Docket No. 50-277

The Commission has issued the enclosed Amendment No. 15 to Facility License No. DPR-44 for Peach Bottom Atomic Power Station Unit 2. The amendment includes Change No. 15 to the Technical Specifications and is in response to your requests dated July 9, 1975 and Supplements thereto dated September 10, 1975, October 1, 24 and 30, 1975, and November 7, 18 and 20, 1975.

ATTACHMENT TO LICENSE AMENDMENT NO. 15
CHANGE NO. 15 TO THE TECHNICAL SPECIFICATIONS
FACILITY OPERATING LICENSE NO. DPR-44
DOCKET NO. 50-277

Figure 8-10a. Maximum Average Planar Linear Heat Generation Rate (MAPLHGR) versus Planar Average Exposure

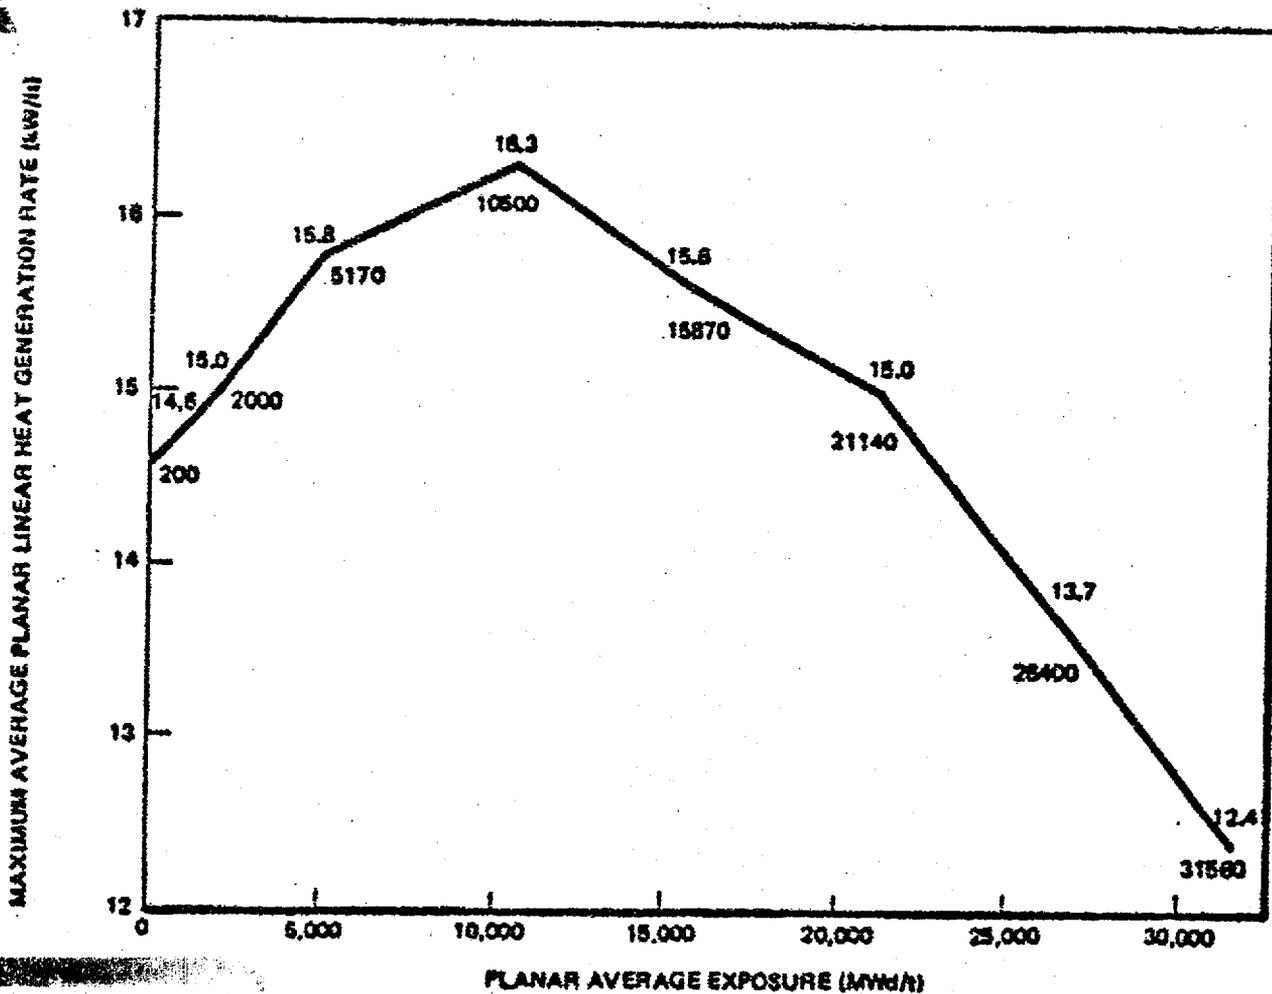
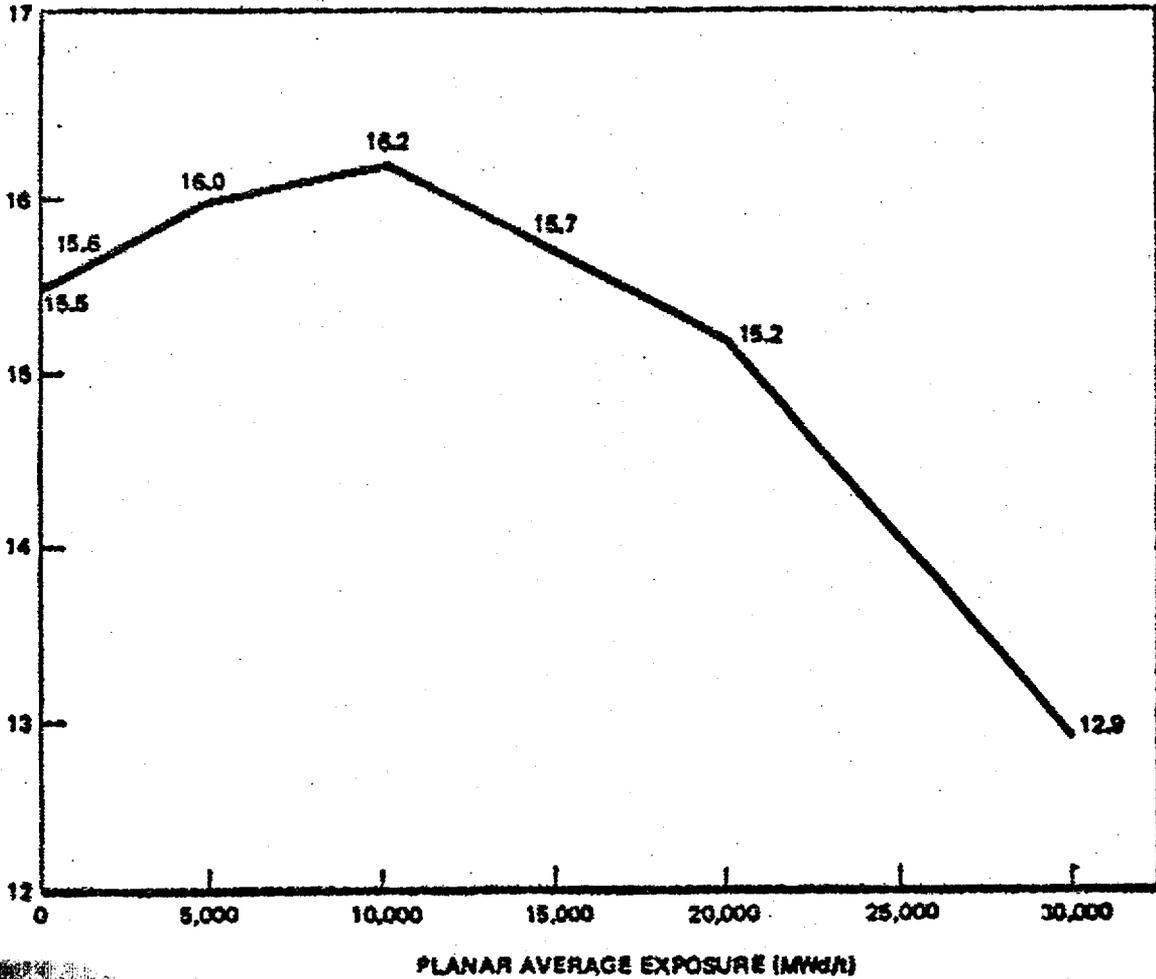
During steady state power operation, the APLHGR for each type of fuel as a function of average planar exposure shall not exceed the limiting value shown in Figure 3.5.1-A, 3.5.1-B, 3.5.1-C or 3.5.1-D as applicable. If at any time during steady state operation it is determined by normal surveillance that the limiting value for APLHGR is being exceeded, action shall then be initiated to restore operation to within the prescribed limits. Surveillance and corresponding action shall continue until the prescribed limits are again being met.

The average planar linear heat generation limits would be revised to be consistent with the analyses performed in accordance with 10 CFR Part 50.46 for operation with plugged bypass holes in the lower core plate.
